ADDENDUM No. 2

MONTEREY REGIONAL AIRPORT
Monterey, California

SKY PARK DRIVE &
2801 MONTEREY-SALINAS HIGHWAY
IMPROVEMENTS

WO 770-23A SHEET 1 OF 4

BID ADDITIVE 1
REPLACE 75 LF
AC DIKE

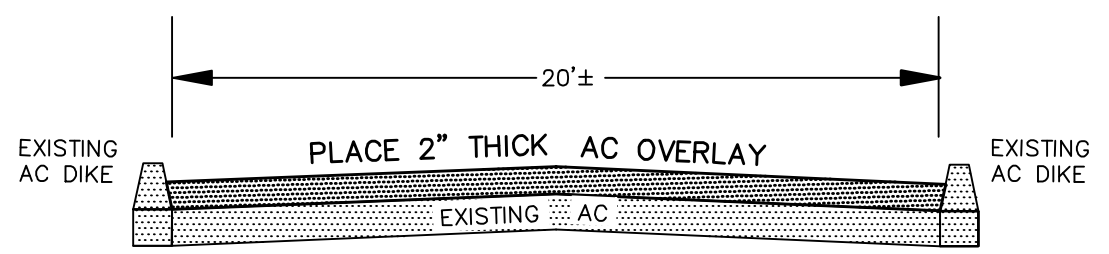
REMOVAL &
REPLACEMENT OF AC
DIKE SHALL INCLUDE
RESTORATION OF AC
BASE SURFACE

DETAIL A

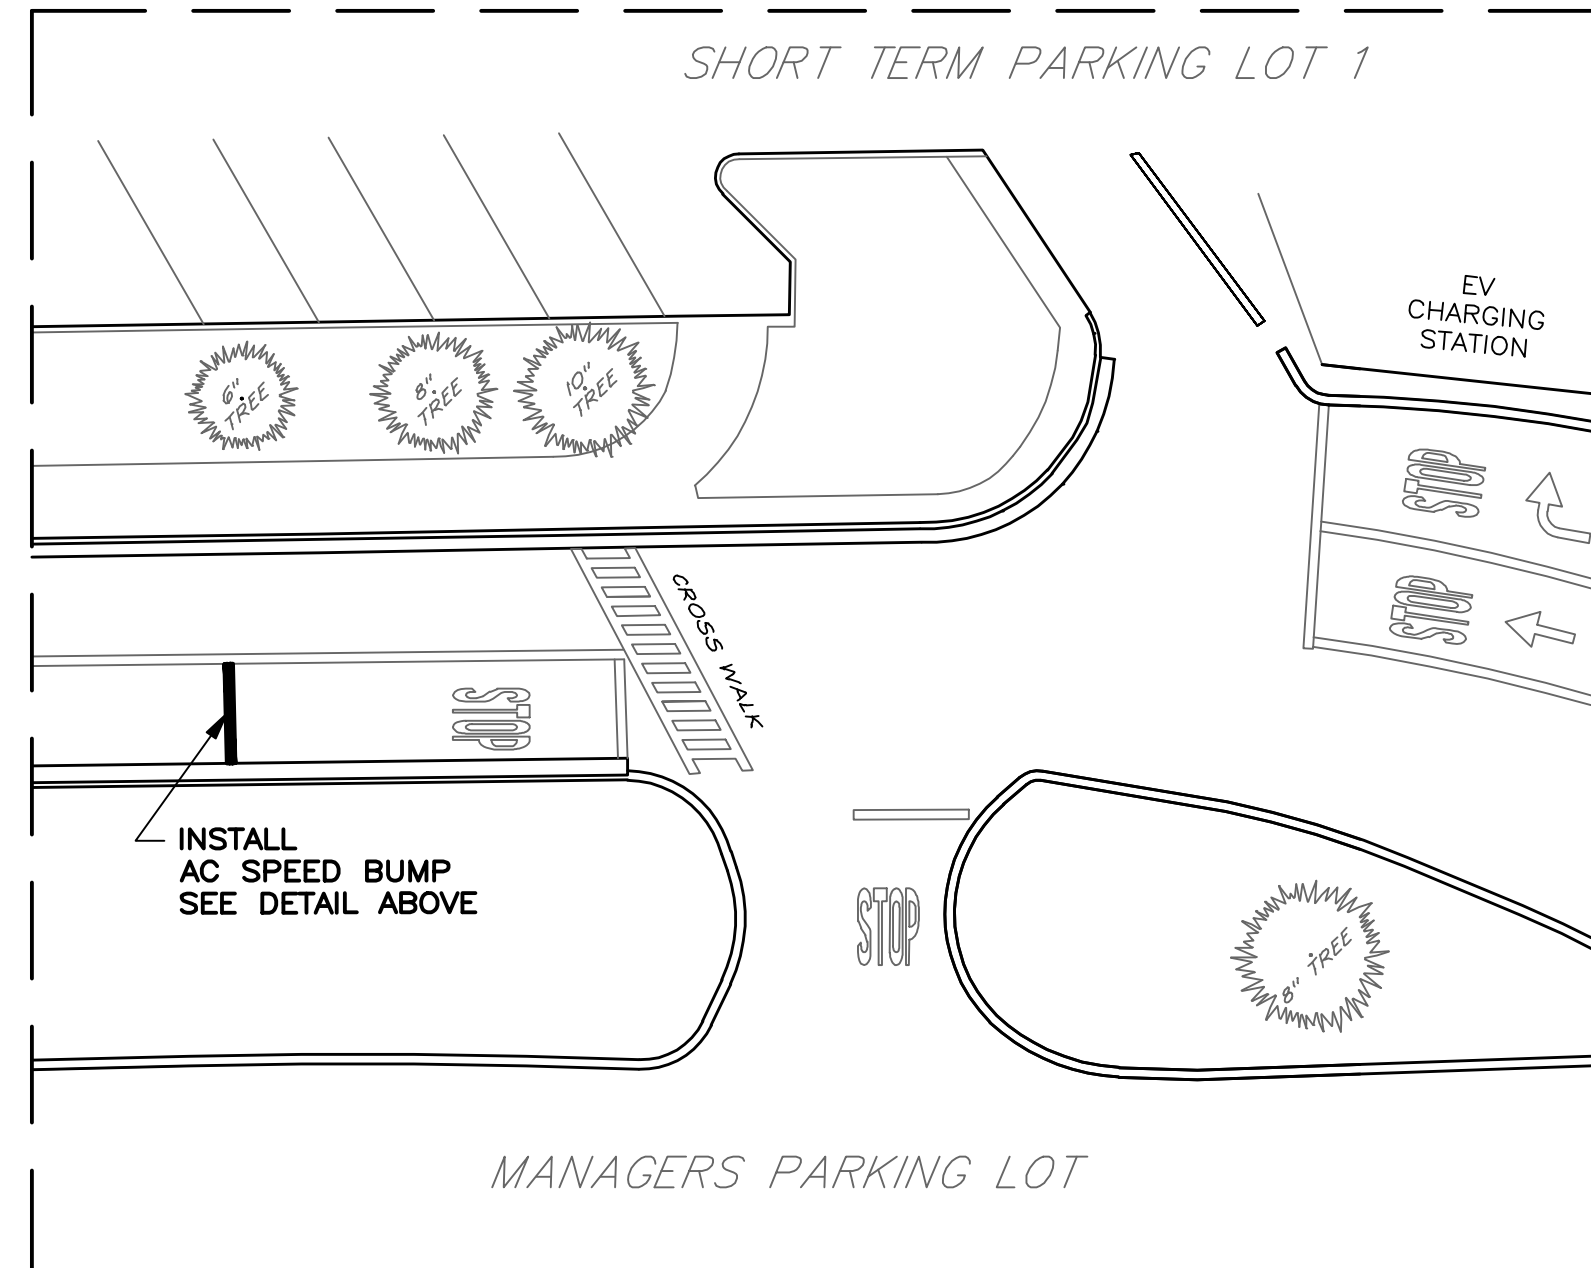
PLACE 2" THICK ASPHALT CONCRETE OVERLAY
APPROX. 30,000 SF
